Site Accessibility Evaluation

Local Rd. Shed

**3571 Utah Ave NE
Iowa City, IA 52240**

ADA Only

Finding: 2

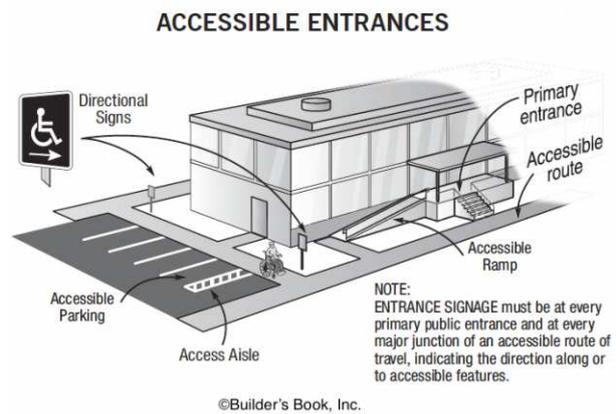
There is no accessible route between the buildings.

building lacks EAR
due to gravel parking
lot

Create AR with crushed and compacted stone or similar outdoor material from building to building within the site

Finding: 4

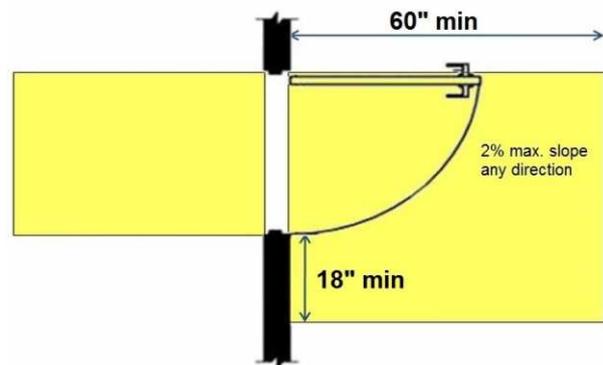
The maneuvering space on the pull side of the door does not adequately extend beyond the latch side of the door.

break room to shop-chair prevents door from opening to 90 degrees

For all doors along the public circulation route, relocate storage, furniture, and other obstacles to create 60" maneuvering space around doors

Finding: 5

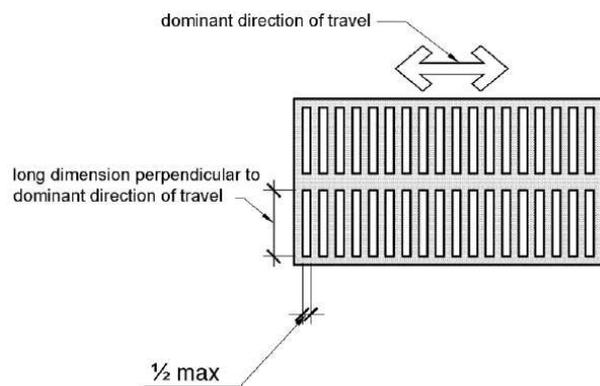
Gratings are spaced greater than a 1/2 inches in the direction of traffic flow.

1" in bays

Replace grate with one having max openings of 1/2 inch.

Finding: 6

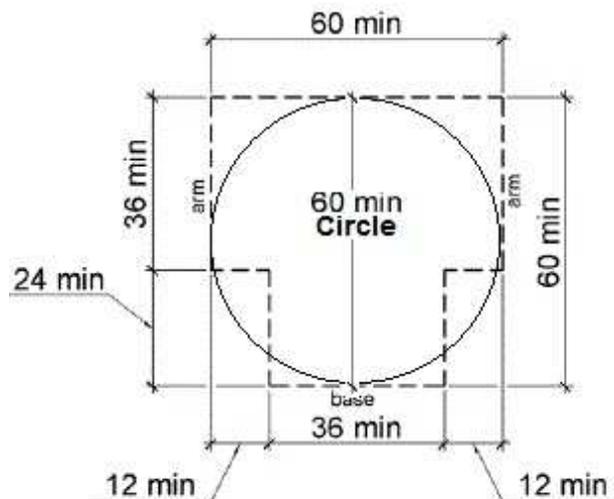
There is insufficient turning space within this room or space.

breakroom lacks
turning and 36 inch
AR due to furniture

Relocate obstacles to create turning space in break room.

Finding: 7

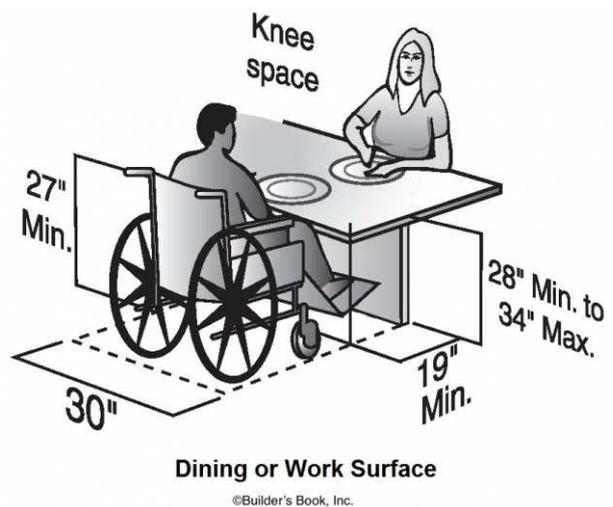
Compliant knee and/or toe clearance is not provided.

break room table
lacks toe clearance

Replace table with one providing required knee and toe clearances

Finding: 8

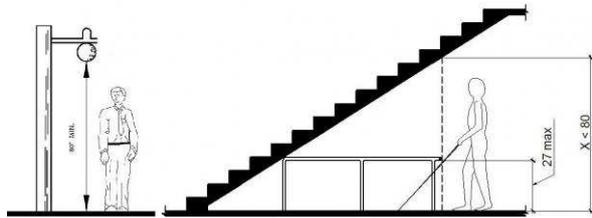
The shelf and cabinet project more than 4 inches into the circulation path.

shelf and cabinet
protrude

Relocate protruding objects or place cane detectable warning or bollard at foot of item

Finding: 9

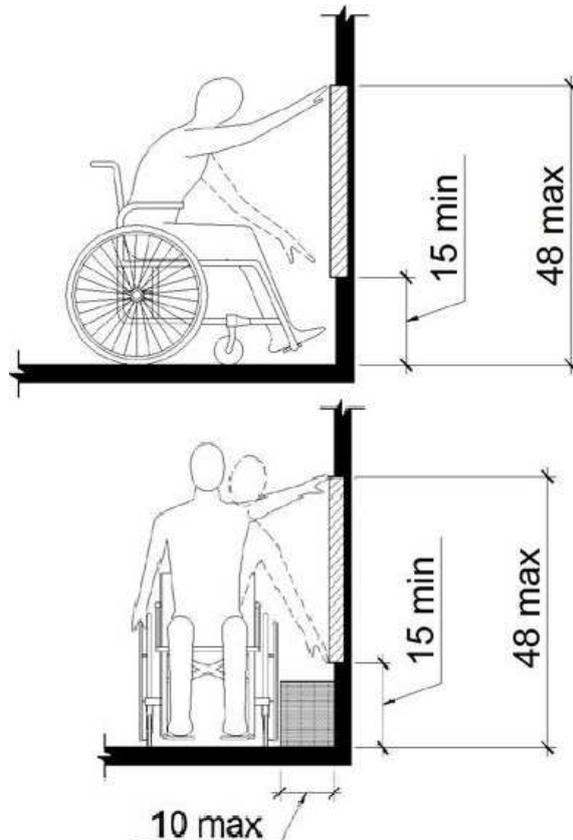
The microwave and toaster are positioned too high for either a side or front approach.

microwave and toaster oven high in break room

Remount operable parts to be in reach range of 15" min to 48" max

Finding: 11

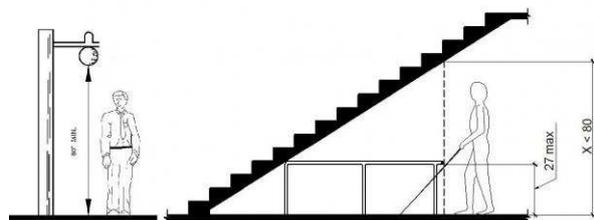
The air conditioner projects more than 4 inches into the circulation path.

air conditioner in
main room protrudes

For deficit, leave as is, employee work area pursuant to 2010 Standards 106.5 Defined Terms, until an employee with a disability works here

Finding: 12

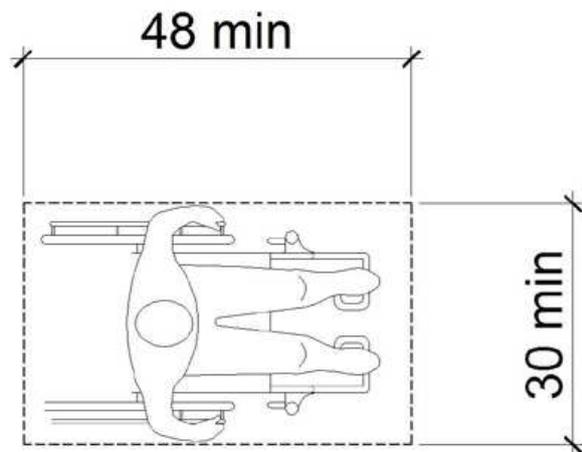
The operable part is not accessible because there is not adequate clear floor space for either a forward or side approach.

no clear floor space at
outlets and garage
door opener

For deficit, leave as is, employee work area pursuant to 2010 Standards 106.5 Defined Terms, until an employee with a disability works here

Finding: 13

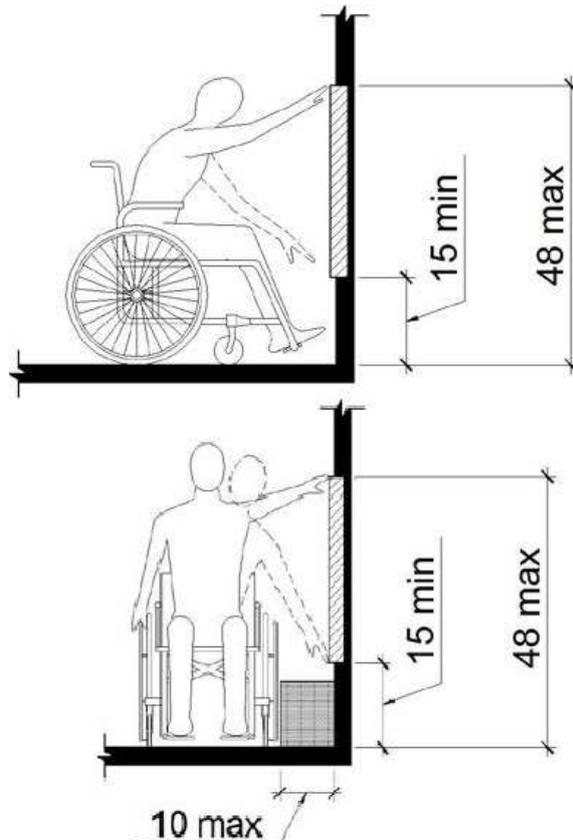
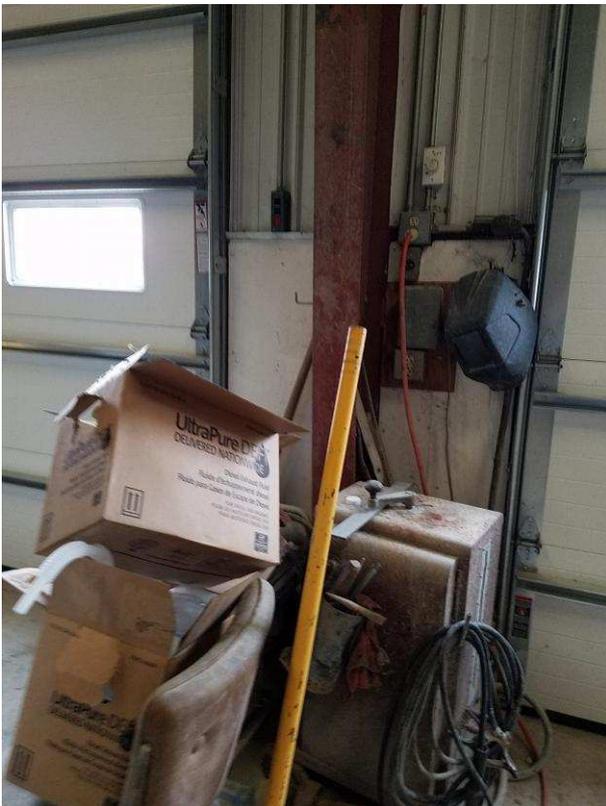
The garage door opener is positioned too high for either a side or front approach.

garage door openers too high

For deficit, leave as is, employee work area pursuant to 2010 Standards 106.5 Defined Terms, until an employee with a disability works here
